SOLICITATION AMENDMENT

Title - Sujet Mechanical & Electrical Sys Upgrade	
Solicitation No. - N° de l'invitation EZ899-161426/A	Amendment No. - N° modif. 008
Client Reference No. - N° de référence du client	Date 2015-12-11
GETS Reference No. - N° de référence de SEAG PW-\$PWY-032-7656	
File No. - N° de dossier PWY-5-38257 (032)	CCC No./N° CCC - FMS No./N° VME
Solicitation Closes - L'invitation prend fin at - à 02:00 PM on - le 2015-12-17	Time Zone Fuseau horaire Pacific Standard Time PST
F.O.B. - F.A.B. Plant-Usine: <input type="checkbox"/> Destination: <input checked="" type="checkbox"/> Other-Autre: <input type="checkbox"/>	
Address Enquiries to: - Adresser toutes questions à: Large, Kathy(pwy)	Buyer Id - Id de l'acheteur pwy032
Telephone No. - N° de téléphone (604) 666-2891 ()	FAX No. - N° de FAX (604) 775-6633
Destination - of Goods, Services, and Construction: Destination - des biens, services et construction: AAFC - Pacific Agri-Food Research Centre - Summerland, BC

This Addendum is raised to incorporate the BidCentral Online Bidding for Subcontractors (BOBS) Pre-Bid Interpretations 4 and 5 and to respond to questions from bidders.

**PACIFIC AGRI-FOOD RESEARCH CENTRE
MECH &

ESK-02

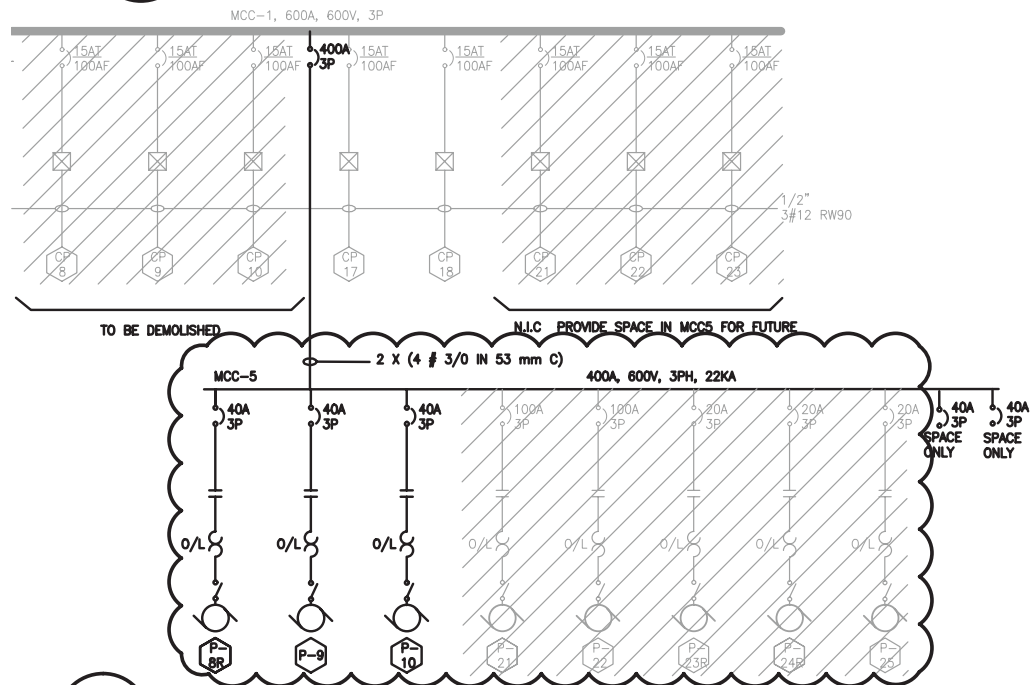
- .1 E-900
 - .1 Revise E-900 detail 3 and detail 4, see enclosed ESK-02.

- .1 Q2: Are we to supplying MCC 5 & MCC 5S
A2: Yes, MCC 5 and MCC 5s are new electrical equipment as identified on Drawings E-150 and E-900.
- .2 Q3: Are we supplying the breakers for these MCC's
A3: Yes, refer to enclosed ESK-02.
- .3 Q4: If we're are supplying MCC's ,please clarify number of ccts required
A4: Refer to enclosed ESK-02.
- .4 Q5: Are we supplying new feeders from MDC-SN to MCC 5S
A5: Refer to enclosed ESK-02.
- .5 Q6: Are we supplying new feeders and breaker from MCC 1 to MCC 5?
A6: Refer to enclosed ESK-02.
